Department of Public Works Riverwalk Site Review Overlay Zone

For the renovation of the Milwaukee Repertory Theater at 108 East Wells Street

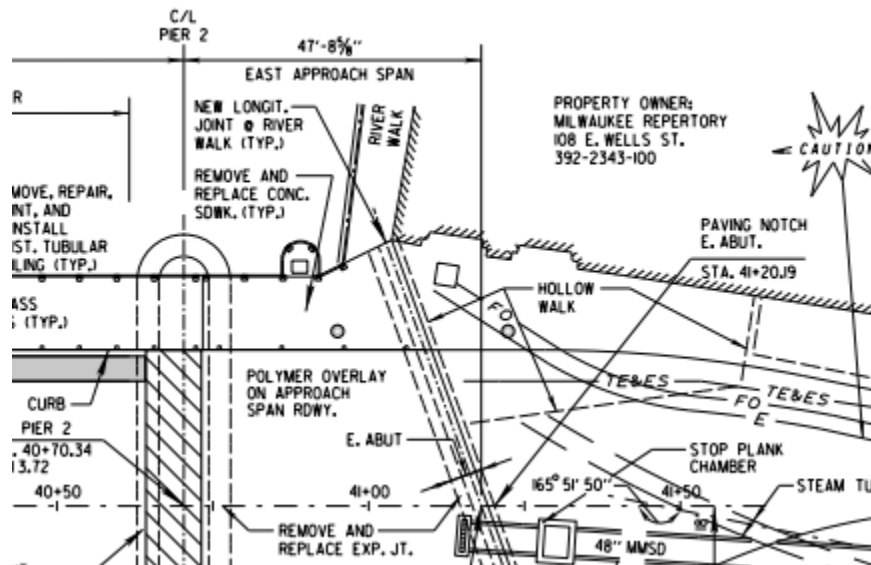
The proposed modifications to the existing curb cut shown in the submittal are in conflict with an existing We Energies vault:

In 2017 the City of Milwaukee and Wisconsin Department of Transportation rehabilitated the Wells Street lift bridge. As part of this work, the City coordinated with We Energies Steam and they replaced the top of the vault structure, installed new waterproofing and the sidewalk topping with mountable curb. This work was coordinated with the Rep facilities manager at the

time. At that time, it was determined that an ADA accessible ramp with no curb is technically infeasible over the vault given the elevation of the top of the steam facility. Therefore, the crossing was constructed at the current location.

In addition, the bridge expansion joint and header would be in conflict with the proposed modifications. Below is a clip of the bridge plans for this corner showing that the vault is directly below the proposed ADA ramp and showing the back of the abutment location and bridge expansion joint.

No modifications can be made to the existing layout of the sidewalk as it would impact We Energies Steam and the City's bridge approach expansion joint.
